# REPLACE ST-2E/ST-3E WITH NEW NCM 300

<b>EWC</b> CONTROLS INC. Englishtown, NJ 07726 Form# 600114A0001A	Drawn By: <b>LYT</b>	Approved By: <b>JPB</b>	Date: <b>1/23/17</b>	Drawing Name: <b>REPLACE ST2E/3E WITH NEW NCM-300</b>
	Size: <b>A</b>	Rev: <b>A</b>	Dwg No: <b>090512A0369</b>	DISCLAIMER: EWC Controls Inc., Cannot be held liable for the use or misuse of this supplied information. It is the responsibility of the user to determine the suitability of the application. Malfunctions, improper operation, and/or subsequent damage to any related equipment or property damage as a result of using this supplied information is the responsibility of the user. EWC Controls Inc., is not responsible for any misapplications including, but not limited to negligence, defect in products(s), system incompatibility, poor workmanship and/or installation.
	Sheet: <b>1 of 1</b>	COPYRIGHT © EWC CONTROLS INC. ALL RIGHTS RESERVED

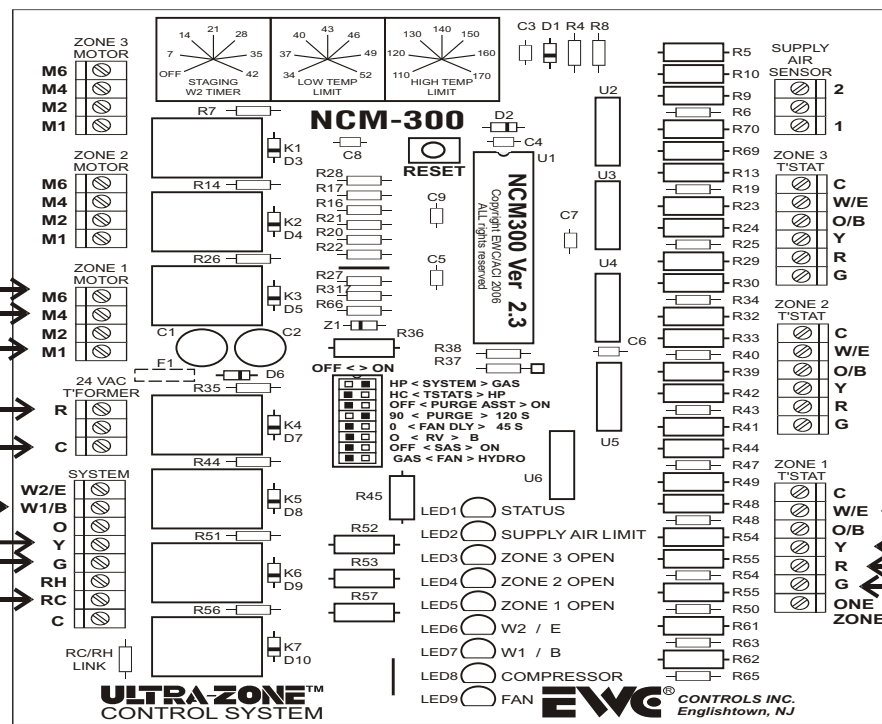
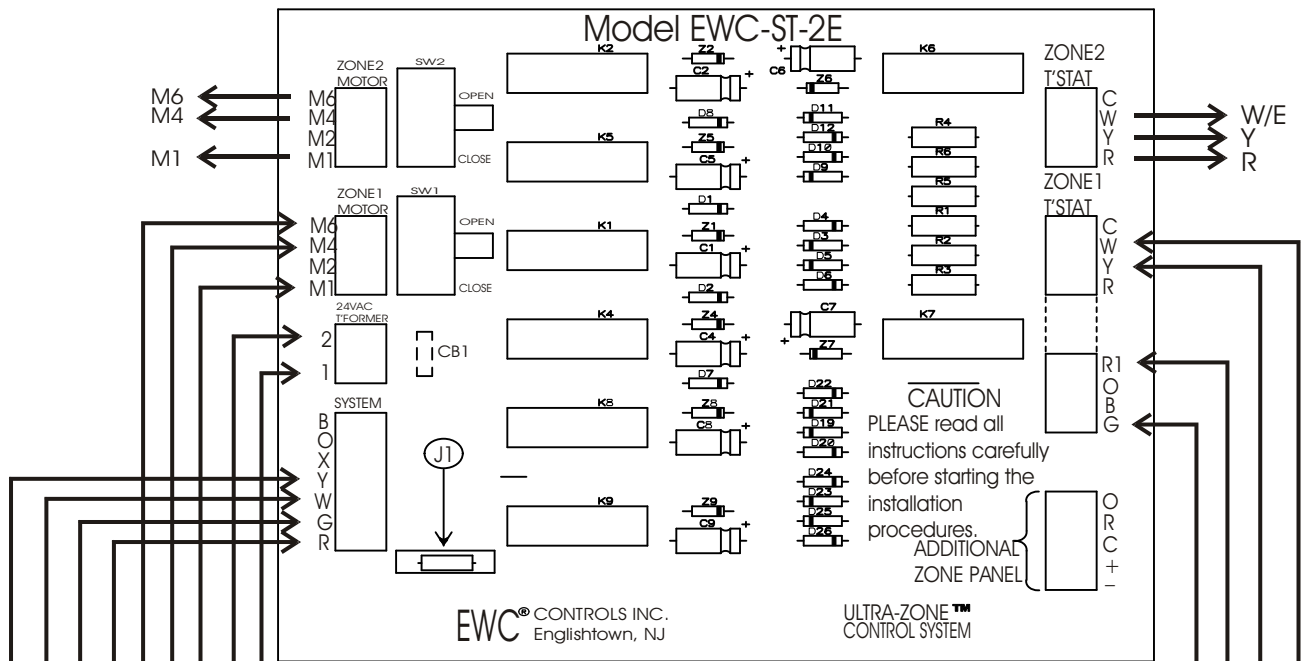
1. Terminals "O" and "B" from Zone 1 Thermostat will no longer be used.
2. You may use the "O" or "B" wire as the new 24V common wire for the new thermostat.
3. Zone 1 and Zone 2 will now function independently.
4. Zone 2 and Zone 3 damper and thermostat wiring not shown for clarity.
